COUNTY OF EL PASO, STATE OF COLORADO
GRADING AND EROSION CONTROL PLANS
DECEMBER 2021

Reviewed by:
Glenn Reese, P.E.
Stormwater Engineer II
GlennReese@ElPasoCo.com
719-675-2654

STERLING RANCH ROAD & BRIARGATE PARKWAY GESC		H-SCALE 1"=60'		No.	REVISION	BY	DATE	 J-R ENGINEERING A Westland Company		PREPARED FOR SR LAND, LLC 20 BOULDER CRESCENT SUITE 201 COLORADO SPRINGS, CO 80903 JAMES F. MORLEY (719) 471-1742	UNTIL SUCH TIME AS THESE DRAWINGS ARE APPROVED BY THE APPROPRIATE REVIEWING AGENCIES, JR ENGINEERING WILL BE RESPONSIBLE ONLY FOR THE PURPOSES DESIGNATED BY WRITTEN AUTHORIZATION.
GRADING AND EROSION CONTROL PLANS		V-SCALE N/A									
		DATE 3/11/2022									
		DESIGNED BY RAB									
		DRAWN BY CGV									
		CHECKED BY									
SHEET 3 OF 9											
JOB NO. 25188.03

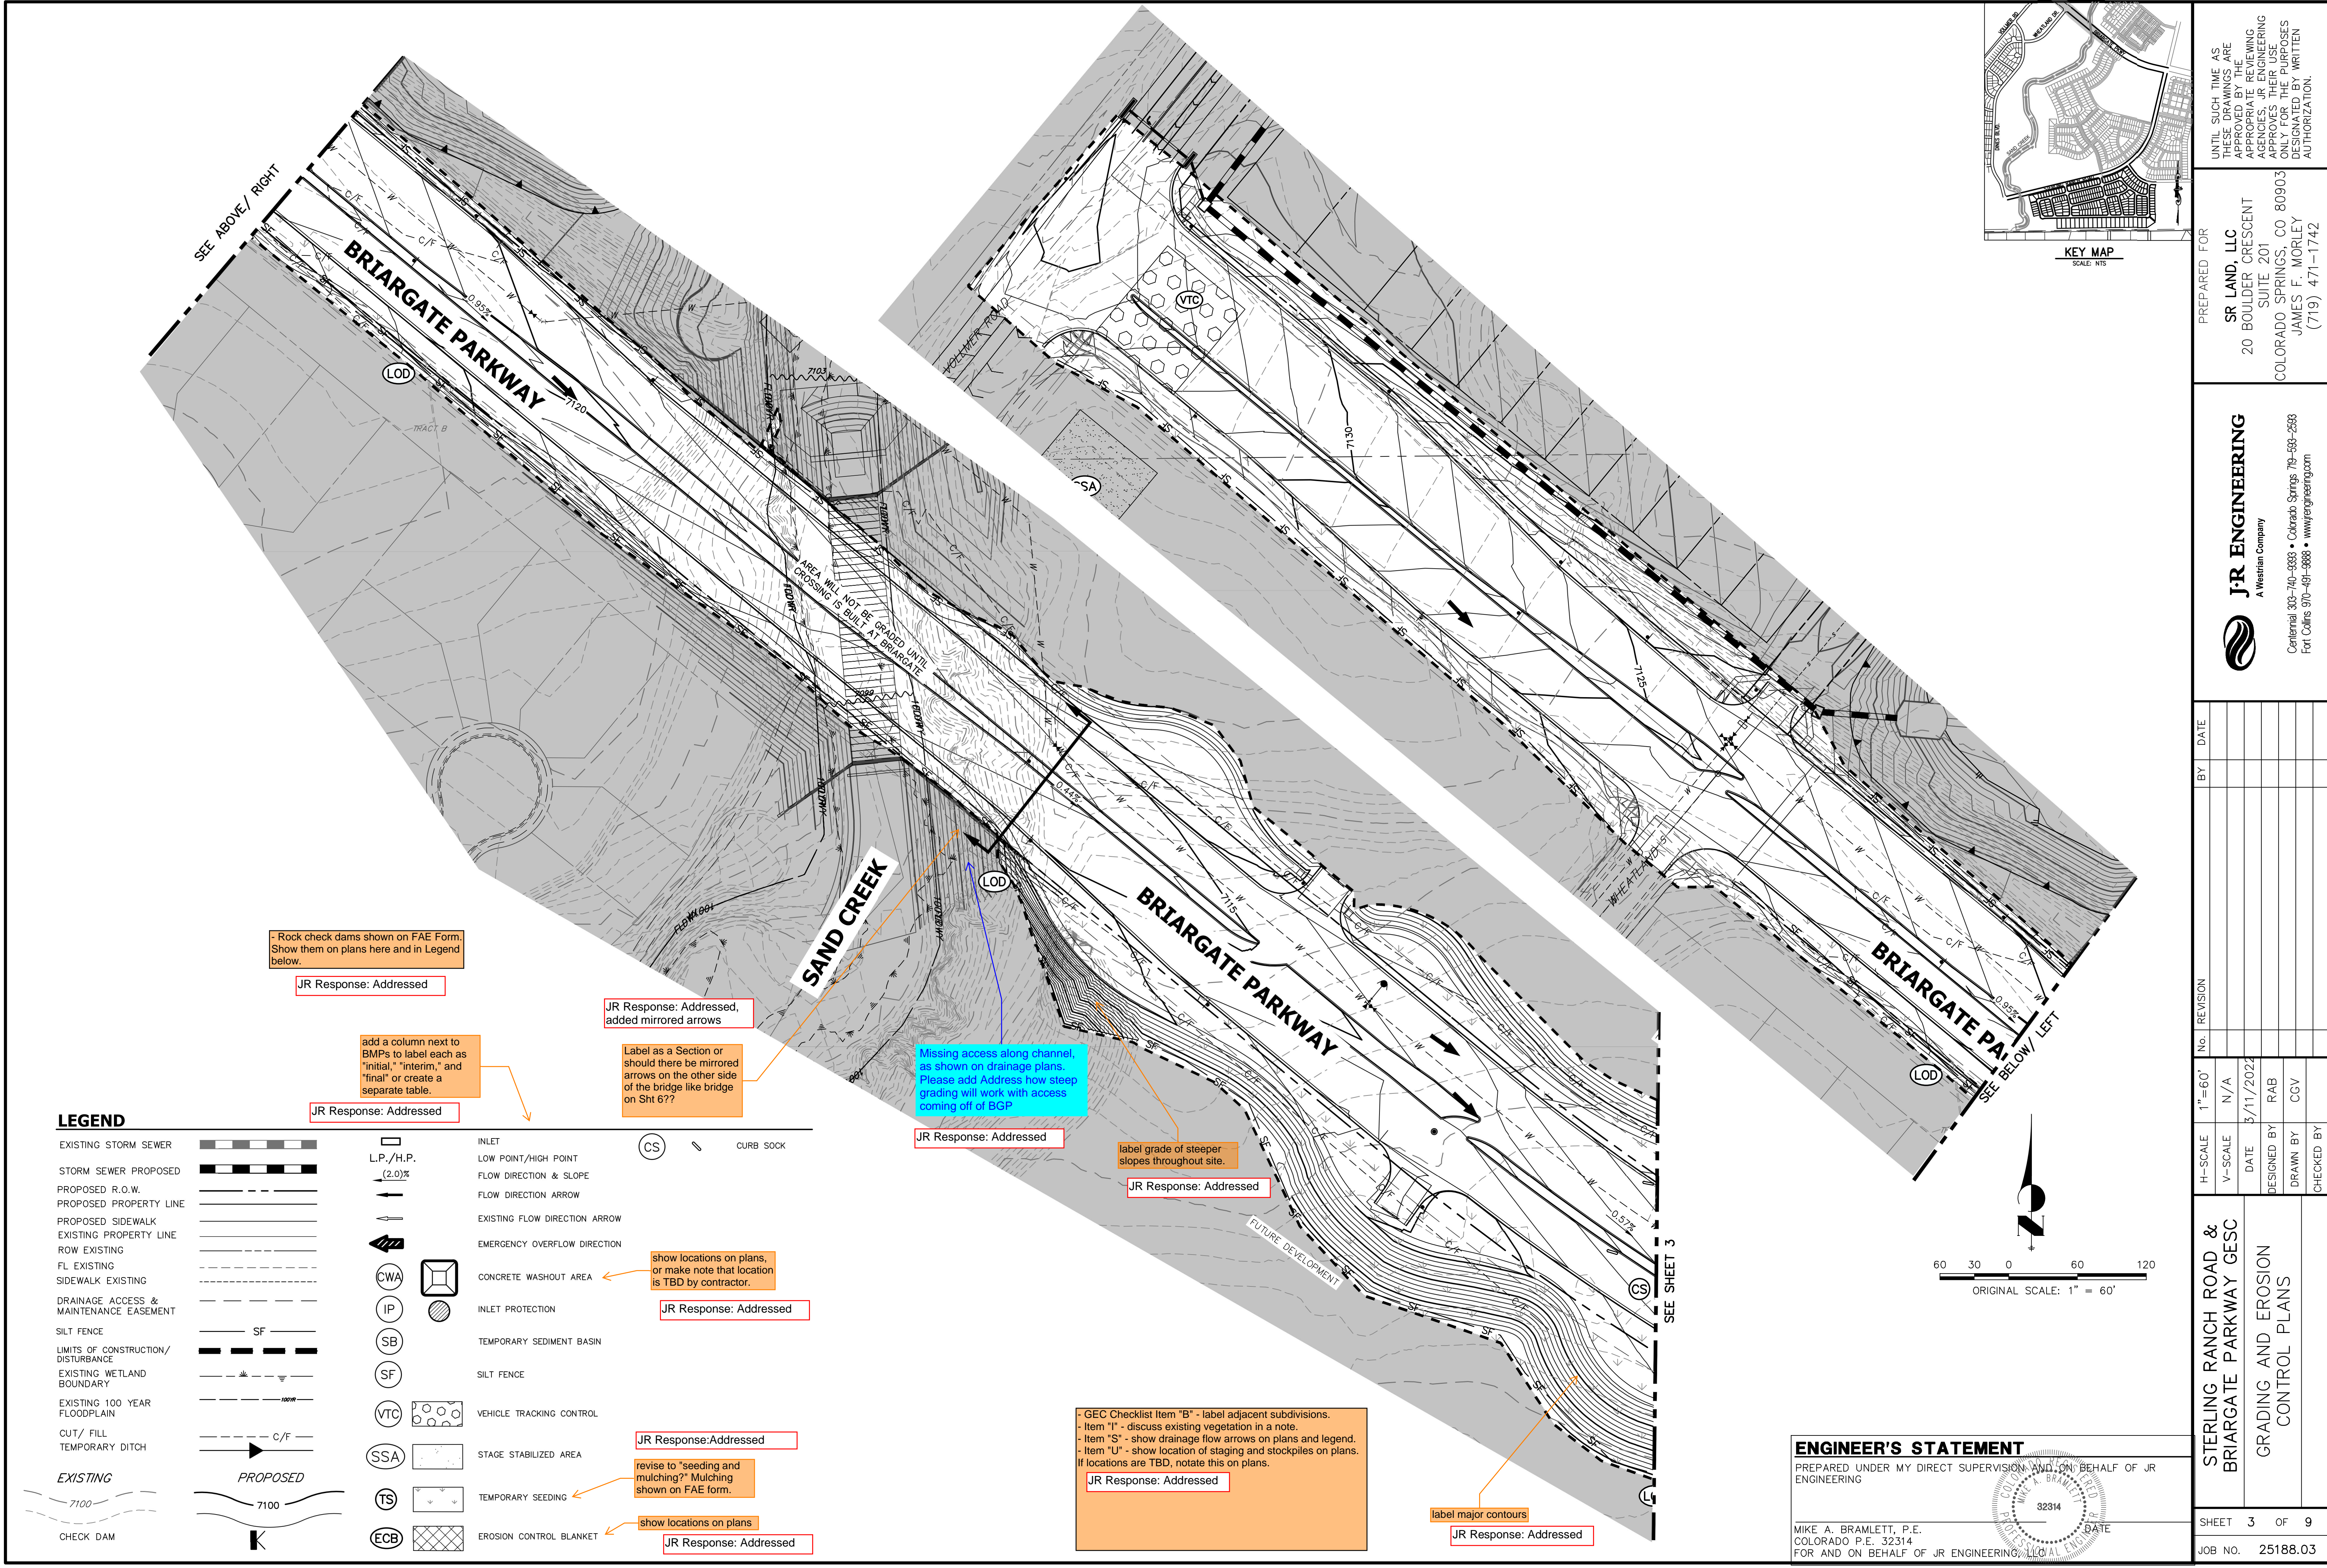
- Rock check dams shown on FAE Form. Show them on plans here and in Legend below.

add a column next to BMPs to label each as "initial," "interim," and "final" or create a separate table.

Label as a Section or should there be mirrored arrows on the other side of the bridge like bridge on Sht 6??

Missing access along channel, as shown on drainage plans. Please add Address how steep grading will work with access coming off of BGP

label grade of steeper slopes throughout site.

show locations on plans, or make note that location is TBD by contractor.

revise to "seeding and mulching?" Mulching shown on FAE form.

show locations on plans

- GEC Checklist Item "B" - label adjacent subdivisions.
- Item "I" - discuss existing vegetation in a note.
- Item "S" - show drainage flow arrows on plans and legend.
- Item "U" - show location of staging and stockpiles on plans.
If locations are TBD, note this on plans.

label major contours

JR Response: Addressed

JR Response: Addressed

JR Response: Addressed, added mirrored arrows

JR Response: Addressed

JR Response: Addressed

JR Response: Addressed

JR Response:Addressed

JR Response: Addressed

JR Response: Addressed

JR Response: Addressed

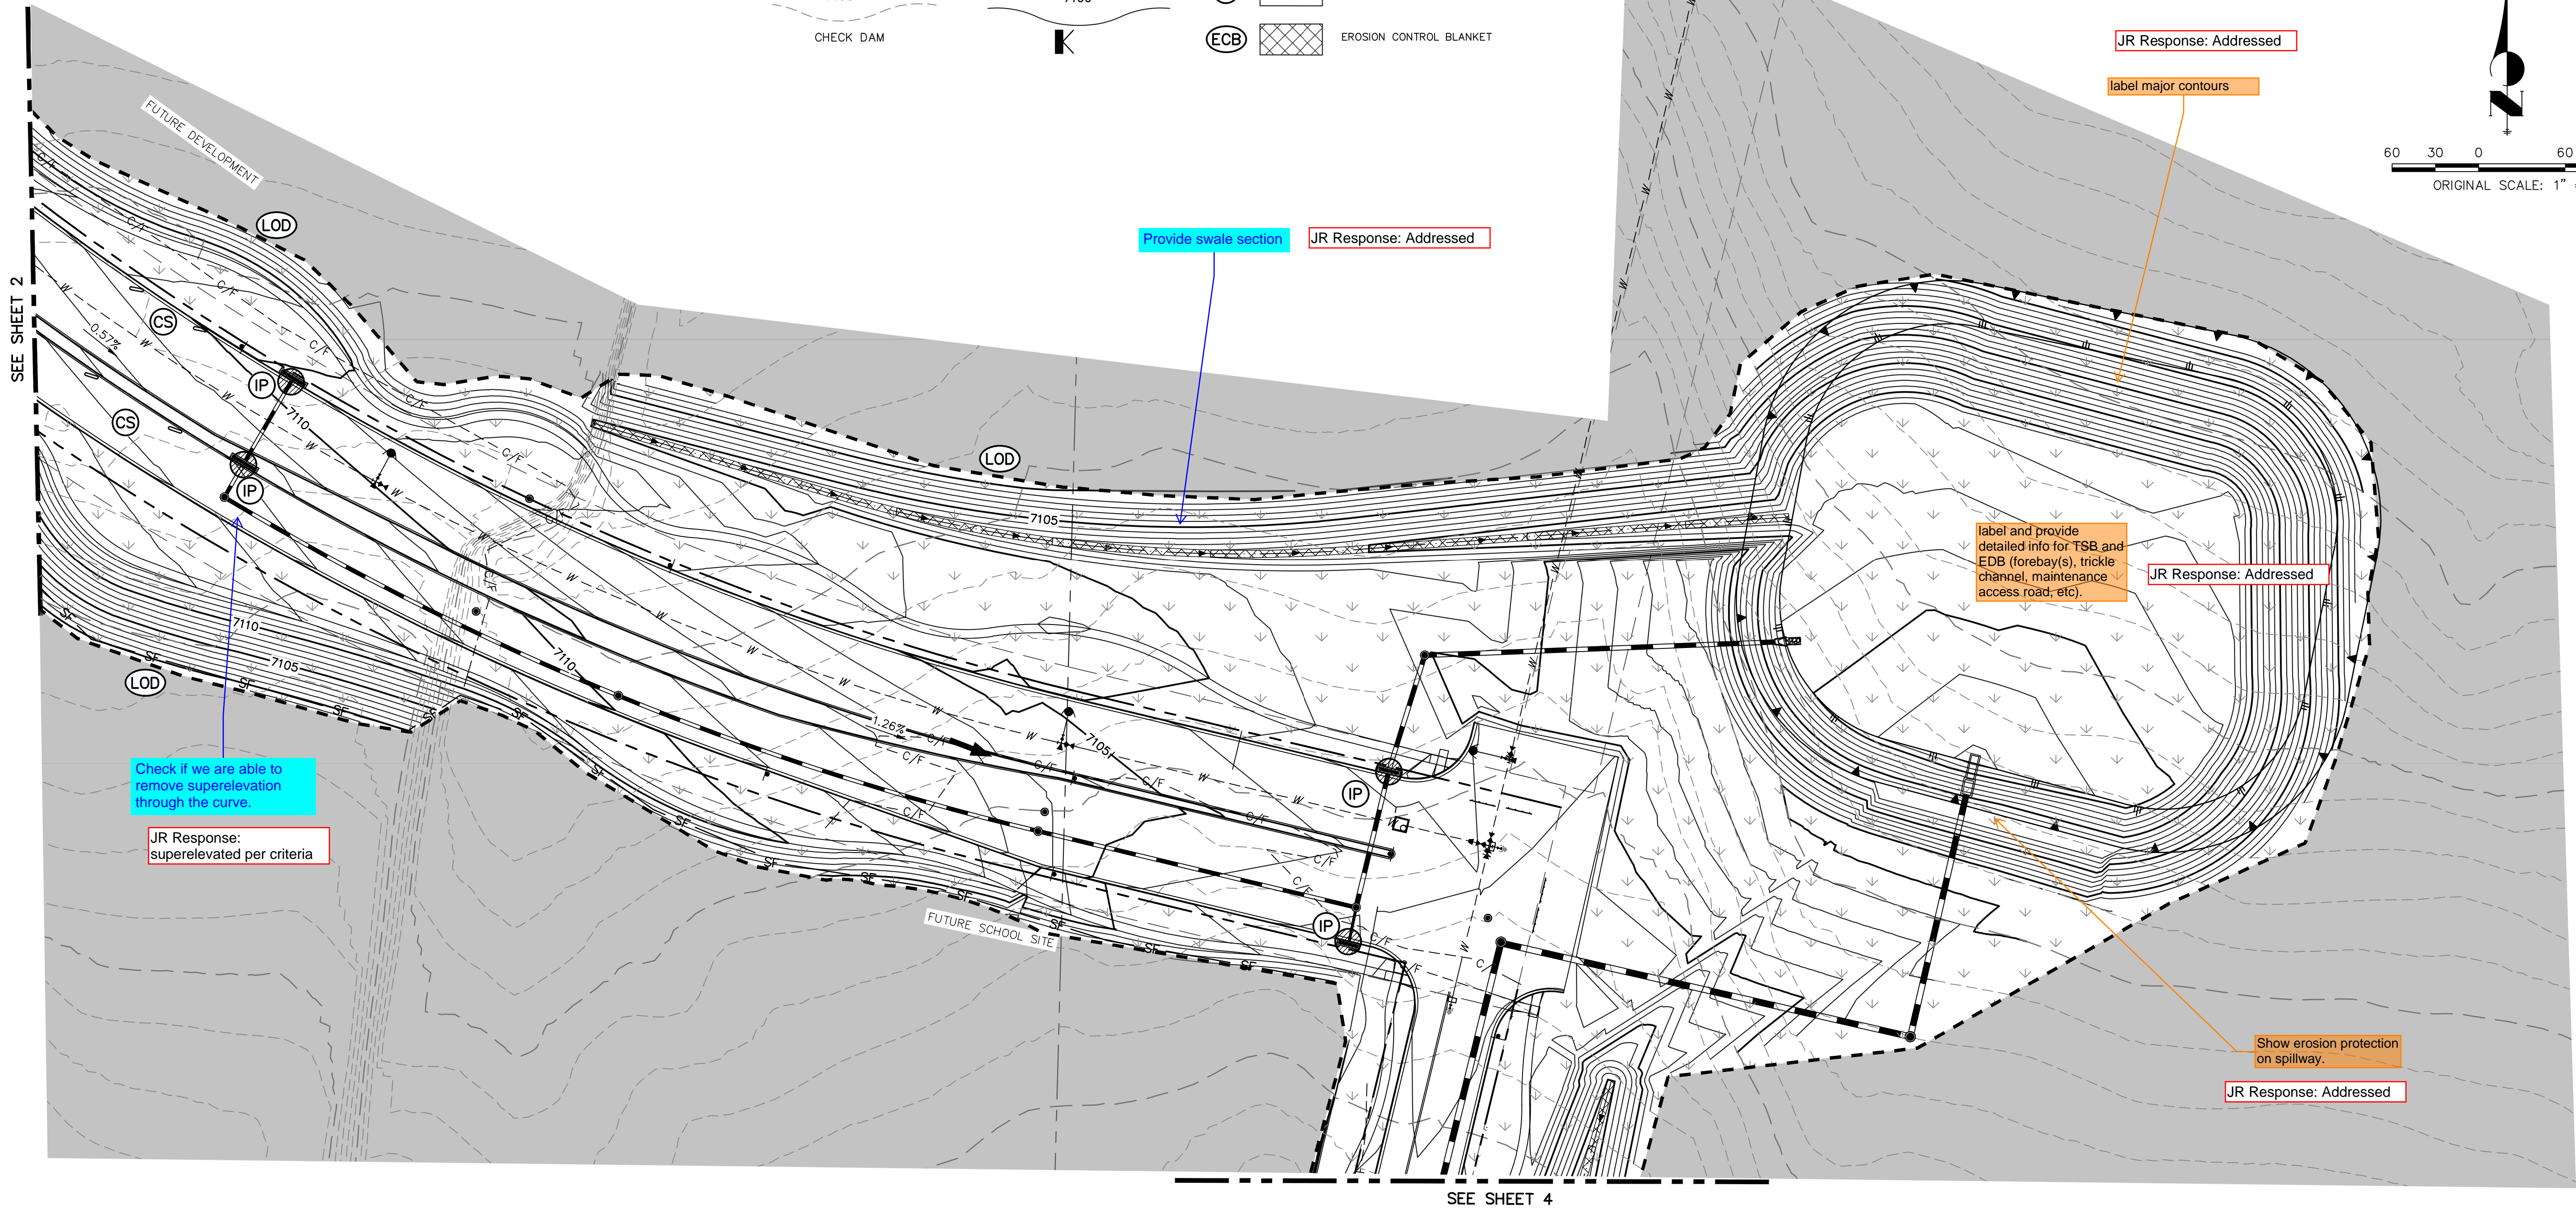
Check if we are able to remove superelevation through the curve.
JR Response: superelevated per criteria

Provide swale section
JR Response: Addressed

label major contours

label and provide detailed info for TSB and EDB (forebay(s), tickle channel, maintenance access road, etc).

Show erosion protection on spillway.

JR Response: Addressed

JR Response: Addressed

JR Response: Addressed

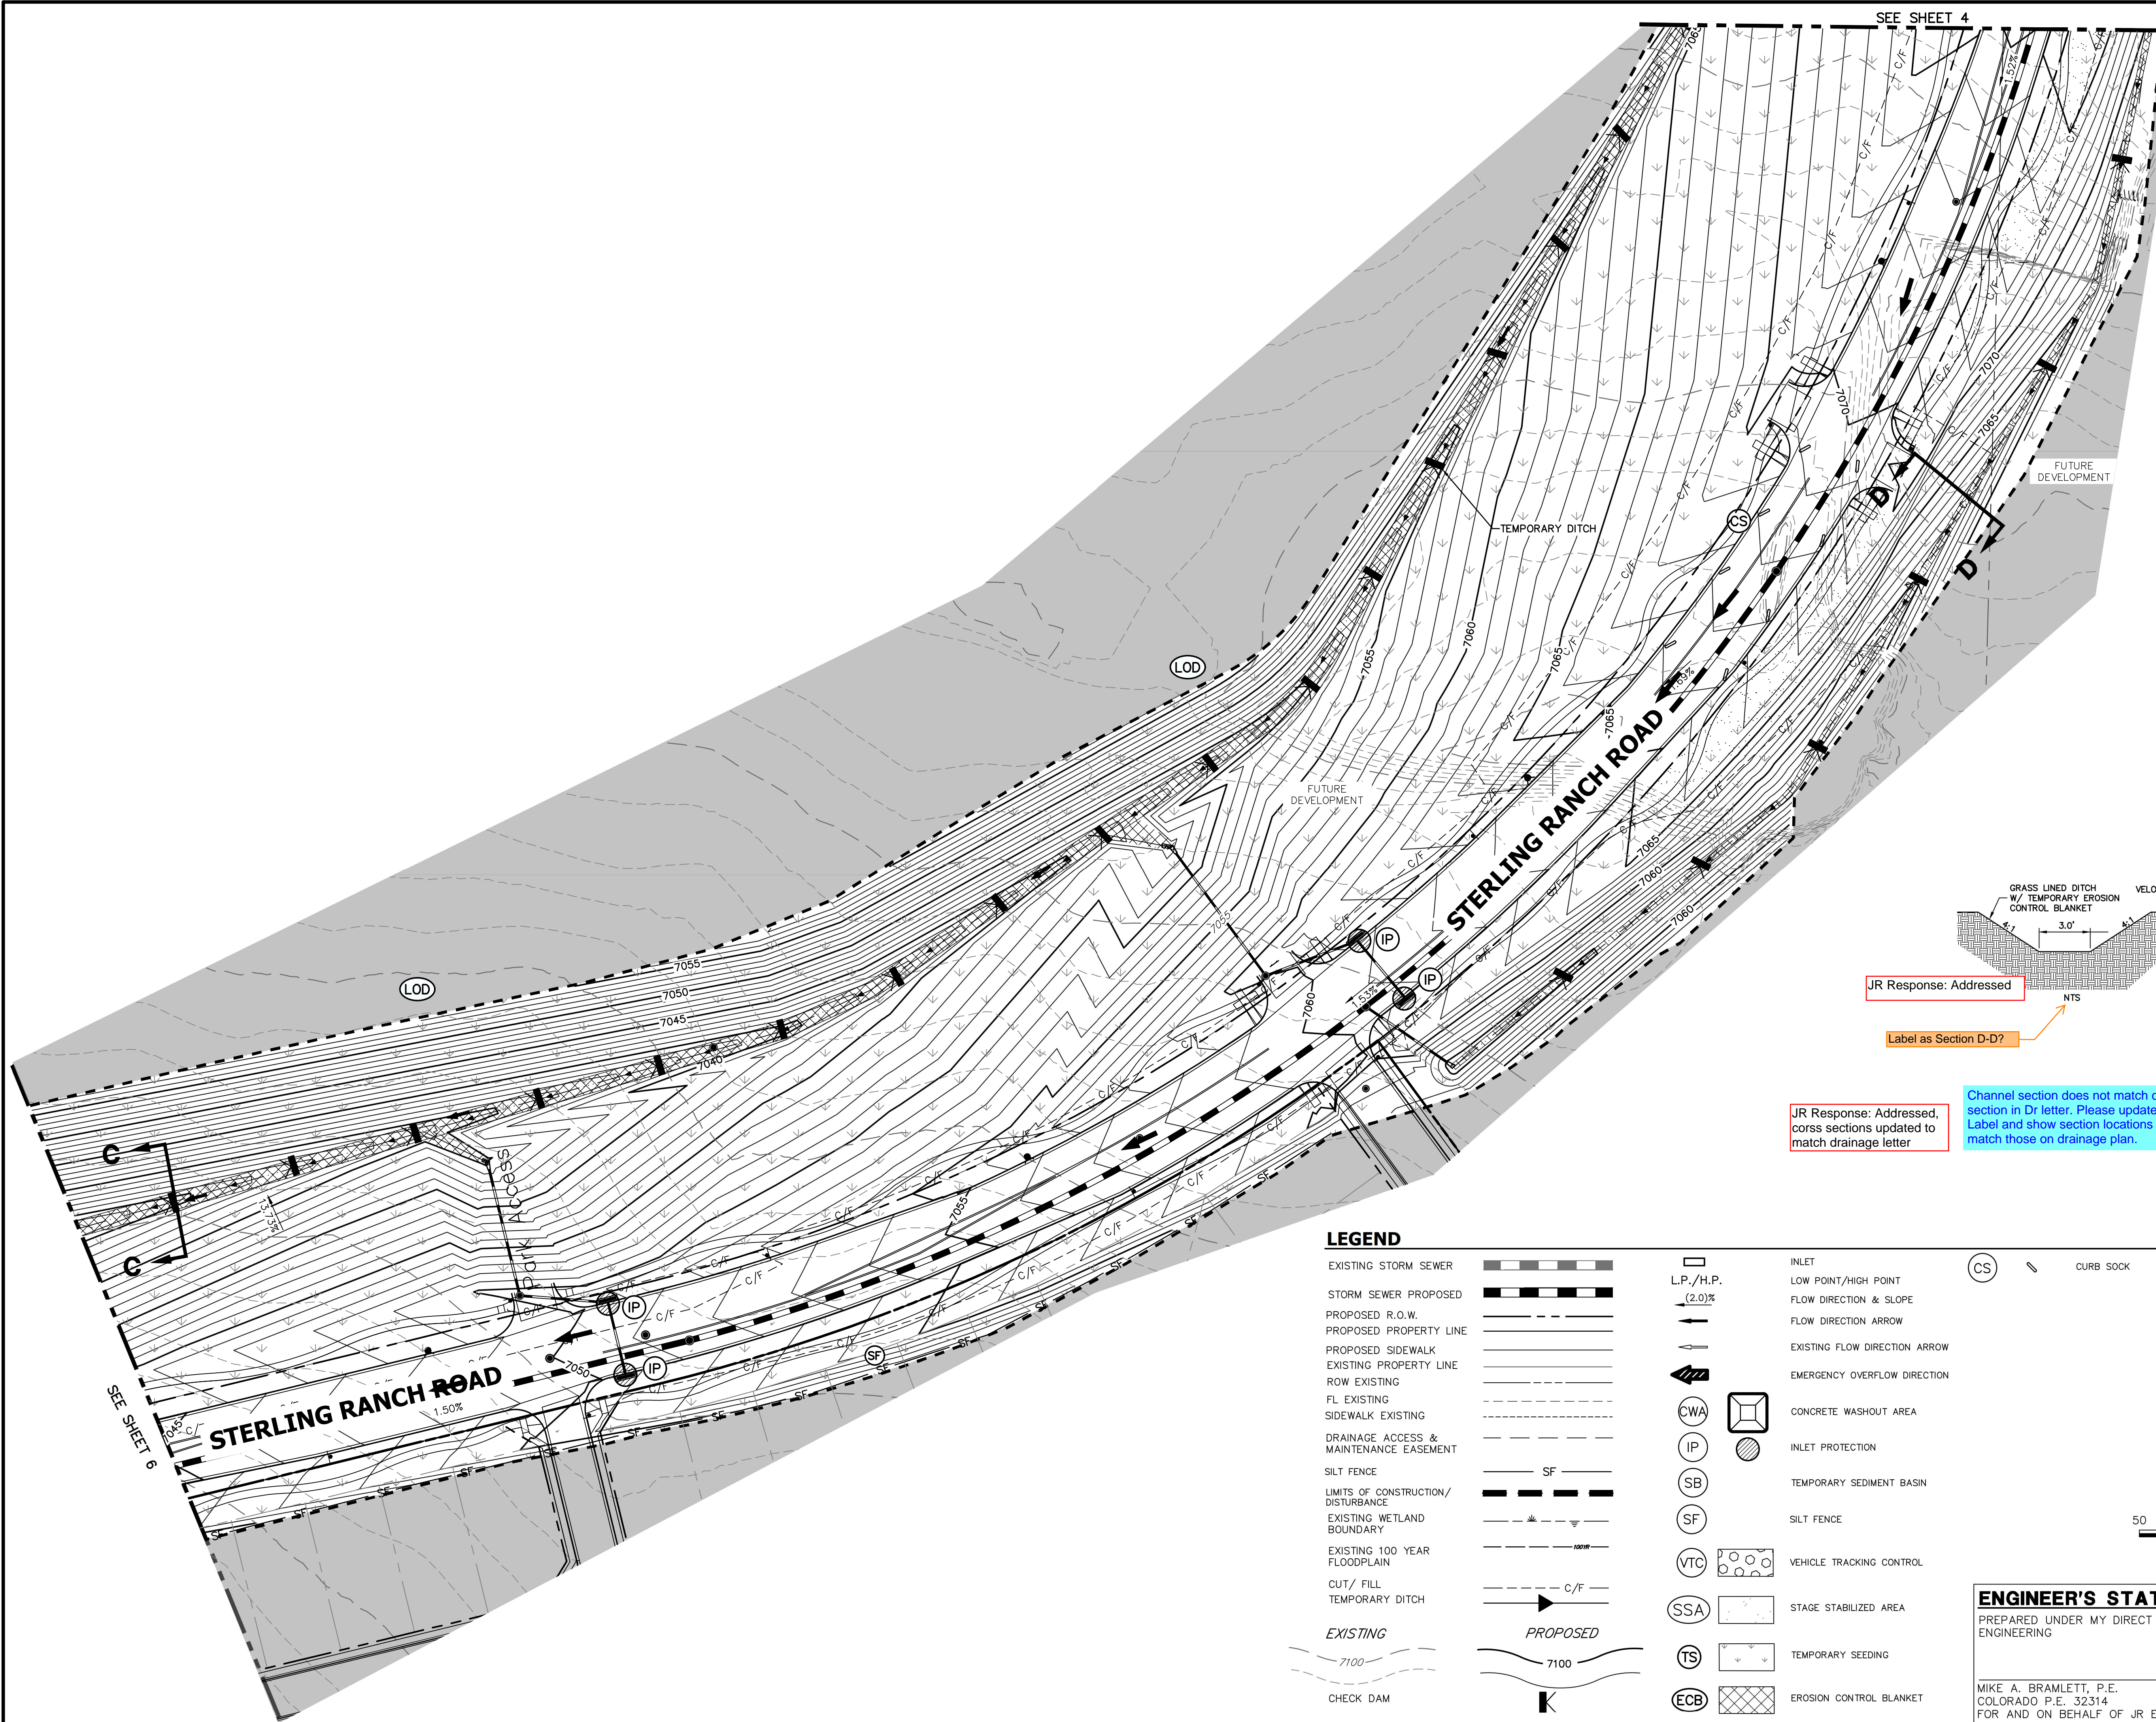
Label as Section D-D?

Channel section does not match design section in Dr letter. Please update Label and show section locations to match those on drainage plan.

JR Response: Addressed

JR Response: Addressed, cross sections updated to match drainage letter
